SUBJECT: COMANCHE PEAK STEAM ELECTRIC STATION
DOCKET NOS. 50-445 AND 50-446
SUPPLEMENT TO LICENSE AMENDMENT REQUEST (LAR) 07-003
RESPONSE TO REQUEST FOR ADDITIONAL INFORMATION RELATED TO
LICENSE AMENDMENT REQUEST ASSOCIATED WITH METHODOLOGY
USED TO ESTABLISH CORE OPERATING LIMITS AND
LAR 07-004 REVISION TO THE OPERATING LICENSE AND TECHNICAL
SPECIFICATION 1.0, "USE AND APPLICATION" TO REVISE RATED THERMAL
POWER FROM 3458 MWT TO 3612 MWT
(TAC NOS. MD5243 AND MD5244) AND (TAC NOS. MD6615 AND MD6616)

Attachment 1 (LAR 07-003, Methodology)
Section 2.8, Anticipated Transients Without Scram

2.8 ANTICIPATED TRANSIENTS WITHOUT SCRAM

Figure 2.8-1 Critical Power Trajectory for Loss of Load ATWS at Uprated NSSS Power Conditions (3,628 MWt)

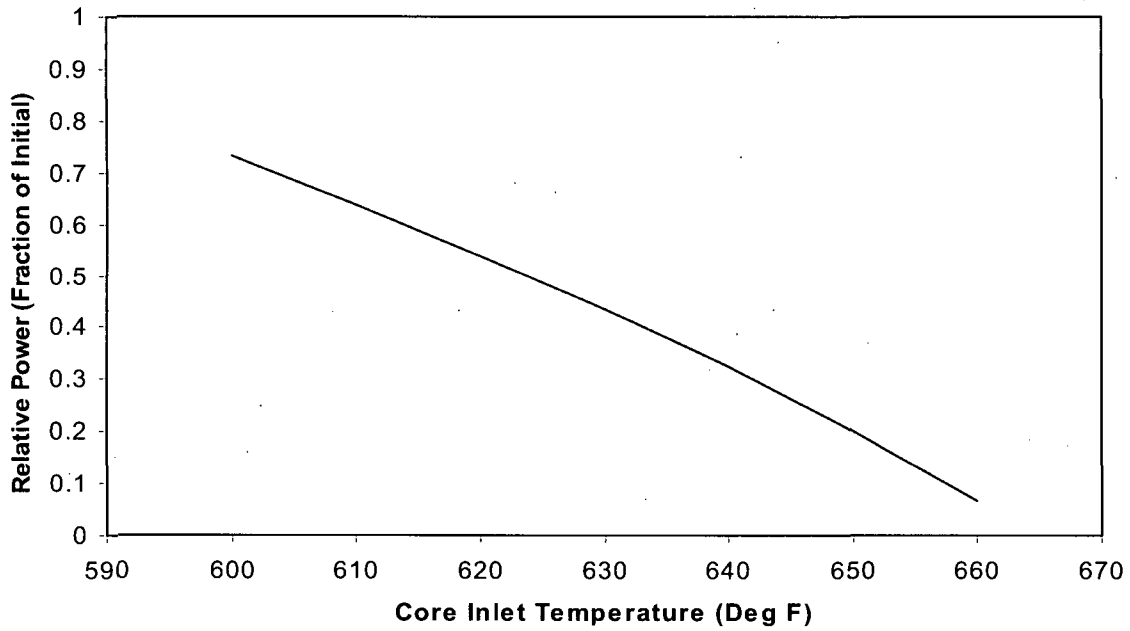
CPT curves were calculated for CPNPP Unit 1 with Westinghouse $\Delta 76$ steam generators at an uprated NSSS power level of 3,628 MWt. These critical power trajectory curves for the LOL and LONF ATWS transients are shown in Figures 2.8.5.7-1 and 2.8.5.7-2, respectively.
